Appl. No. 09/693,019  
Amdt. April 20, 2004  
Reply to Office Action of February 3, 2004

**Amendments to the Drawings:**

**FIG. 1**  
(PRIOR ART)

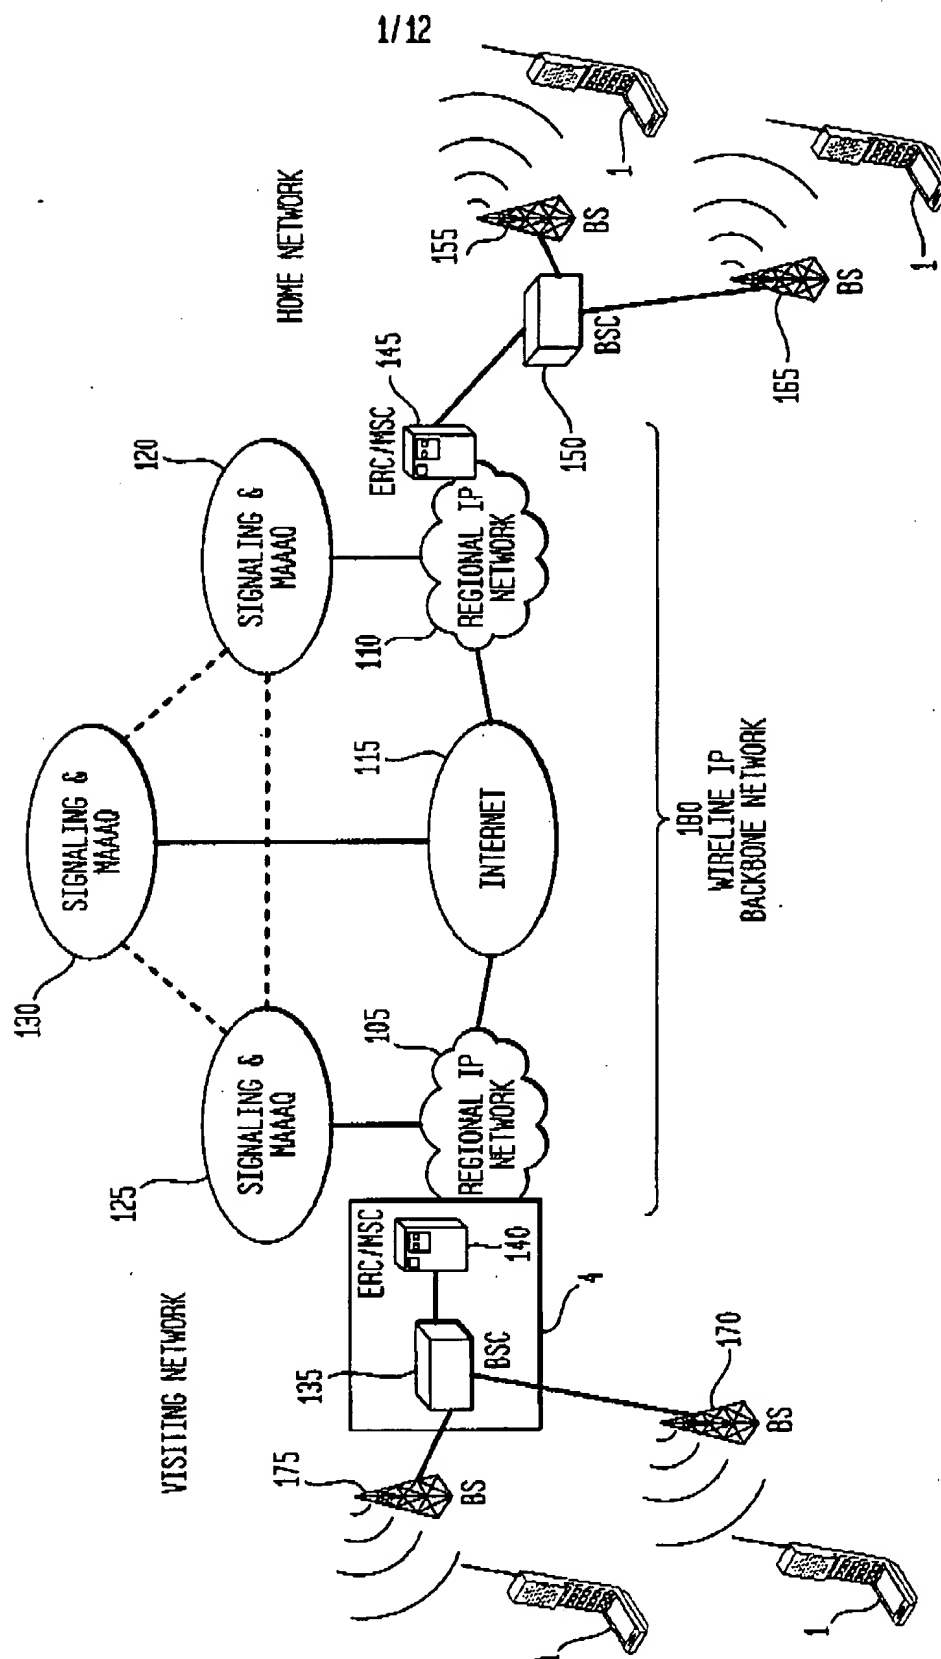
The drawings have been amended to identify Figs. 1 and 2 as Prior Art, to correct the tunnel T in Fig 9A to agree with the description in the specification at page 29, lines 23-25, and to correct the tunnel T in Fig. 10A to agree with the description in the specification at page 30, line 25 and page 31, line 3.
